Staff Report & Recommendation

Historic Preservation Board

SUBJECT: HPB19-0315, **1001 and 1021 Collins Avenue.**

An application has been filed requesting a Certificate of Appropriateness for the rehabilitation of the existing building at 1021 Collins Avenue, including substantial demolition, partial reconstruction, the construction of rooftop and ground level additions and a new elevated pedestrian bridge above the Ocean Court alley, one or more waivers, including variances to reduce the minimum size required for hotel units and to reduce the off-street parking requirements.

1021 Collins Avenue, 1985

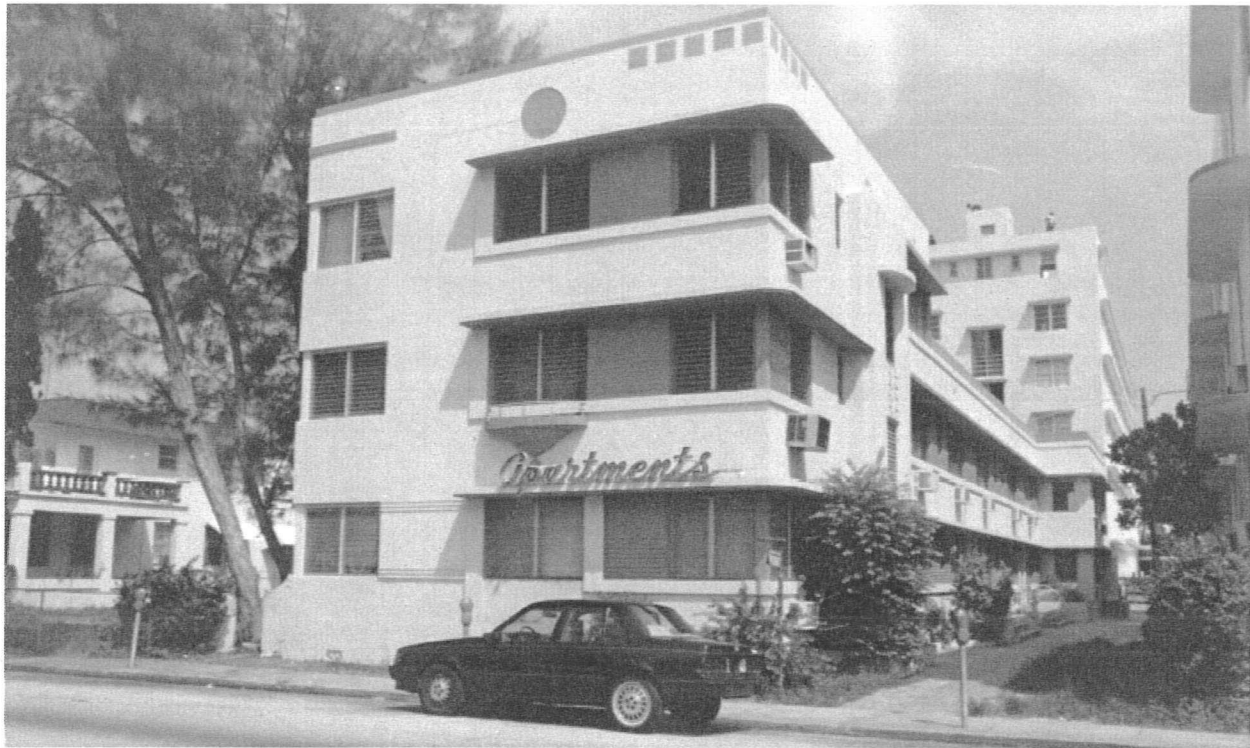
The existing 2 and 3-story annex building, is a very good example of low scale multi-family residential architecture designed in the Streamline Moderne style. The Contributing building features numerous significant architectural details on both the front (Collins Avenue) and the interior courtyard facing façades of the building. These elements include projecting rounded corner eyebrows, horizontal fluting between windows, raised stucco detailing, side entrance features with landscape courtyard, cascading planter features and projecting balconettes.

The proposed project can be best described in three separate components; the front 3-story portion, the center 2-story wing with side entrances and the rear 2-story portion along the alley.
